UNITED STATES PATENT AND TRADEMARK OFFICE

APPLICATION NO.	FILING DATE	FIRST NAMED INVENTOR	ATTORNEY DOCKET NO.	CONFIRMATION NO.
10/755,356	01/13/2004	Motoari Ota	0649-0933P	9821

Office Action Summary

DETAILED ACTION

Fig. 12

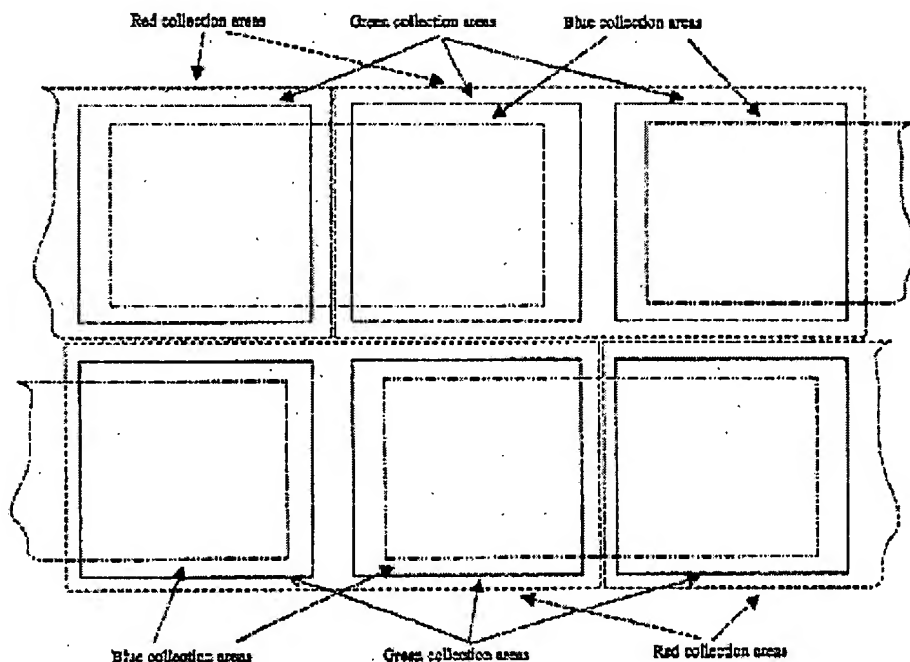
Limitations (d), (e), and (f) of claim 2 are all taught by Turner in Figure 12 of the prior art. Any single "collection area" of a specific color, e.g. a "green collection area," teaches limitation (d). Any combination of two "collection areas" of two different colors teaches limitations (e) and (f). In this analysis, the word "area" is considered a synonym of "region," where region can be defined as a large, usually continuous segment of a surface or space.

12. Claim 6, viewed in light of claims 2 and 5, shares the limitations of claim 5, discussed above, and adds the limitation: the first spectral sensitivity corresponds to a spectral sensitivity of a green color. As mentioned above, Figure 12 discloses a "green collection area" that teaches limitation (d) of claim 2 as well as satisfies this additional limitation of claim 6.

FIG. 1

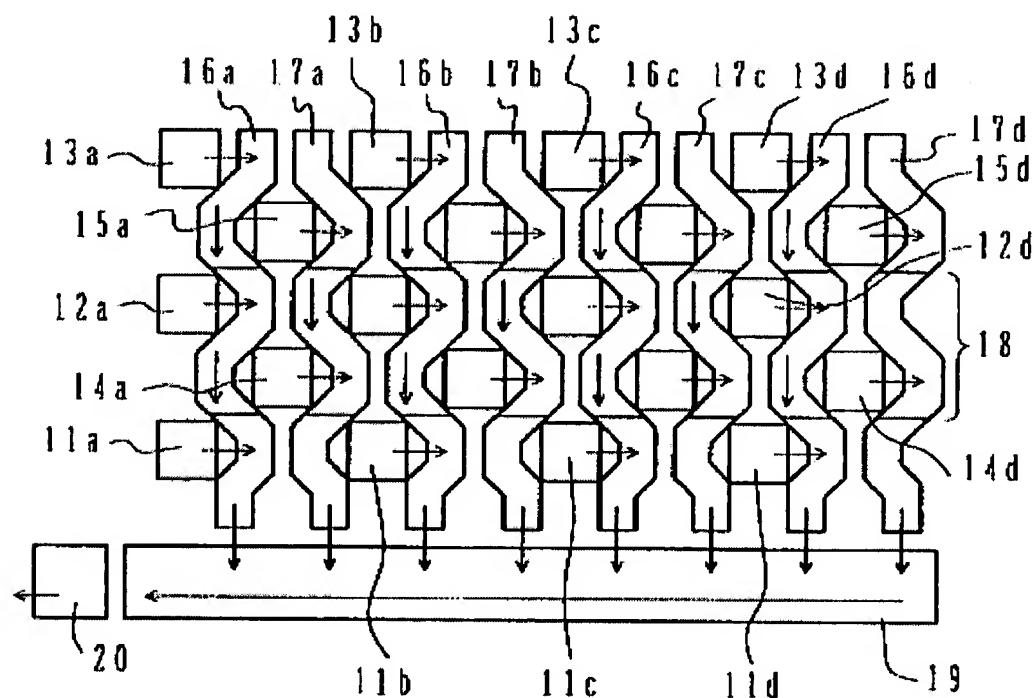
Yamada, like Turner, teaches a solid-state image pickup device, but focuses his invention on "a novel layout of its components." Figure 1 clearly shows the limitations: a vertical transfer portion (16a), corresponding to limitation (g); a horizontal transfer portion (19), corresponding to limitation (h); and an output portion (20), corresponding to limitation (i).

Yamada, like Turner, teaches a solid-state image pickup device, but focuses his invention on "a novel layout of its components." Figure 1 clearly shows a honeycomb layout of photosensitive regions (11a-d, 12a-d, 13a-d, 14a-d) that matches the layout described in limitation (j).
